## Circuit Analysis Report

Test IC	AT86RF212	
Crystal	Holder	NX5032GA
	Frequency	16.000MHz
	Load capacitance	CL=8pF (Current) <b>CL=10pF (Suggested)</b>
	NDK Spec. No.	STD-CSK-8(J) (*J:CL=10pF)
Test Circuit	IC	ATRF212 58902-01 1018 PH 8S5817-9
	VDD	+3V / +1.8V
	PCB	TB3_XMEGA_212 AVR2067 - Crystal Characterization for AVR RF

### 2. CIRCUIT DIAGRAM

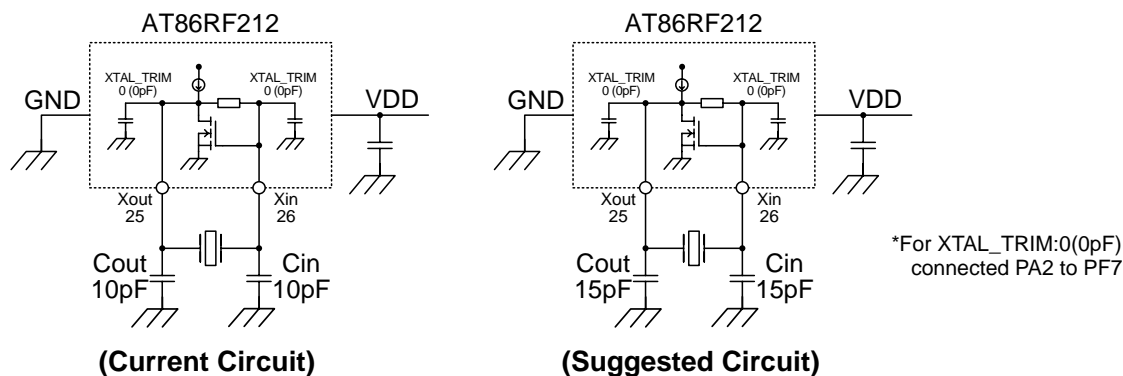
- 1) This crystal unit requires negative resistance of  $-R = 700\Omega$  minimum for stable oscillation
- 2) Circuit characteristics

- 3) Although the negative resistance of the current circuit is over our target, it seems too large.
- 4) In order to improve negative resistance, we recommend changing external capacitance values from Cout/Cin=10pF/10F to **Cout/Cin=15pF/15pF**. Besides, we recommend changing crystal load capacitance value from CL=8pF to **CL=10pF** in order to improve frequency deviation.

Circuit	Cout/Cin	XTAL_TRIM (Internal Cap)	Frequency deviation dF/F	Negative Resistance -R	Drive Level DL	Startup time Tstr
Current	10pF/10pF	0 (0pF)	+8ppm (CL=8pF[IEC])	3410 $\Omega$	Less than 10uW	1ms
Suggested	15pF/15pF	0 (0pF)	<b>+2ppm (CL=10pF[IEC])</b> Ref.: -37ppm (CL=8pF[IEC])	2090 $\Omega$	Less than 10uW	1.5ms
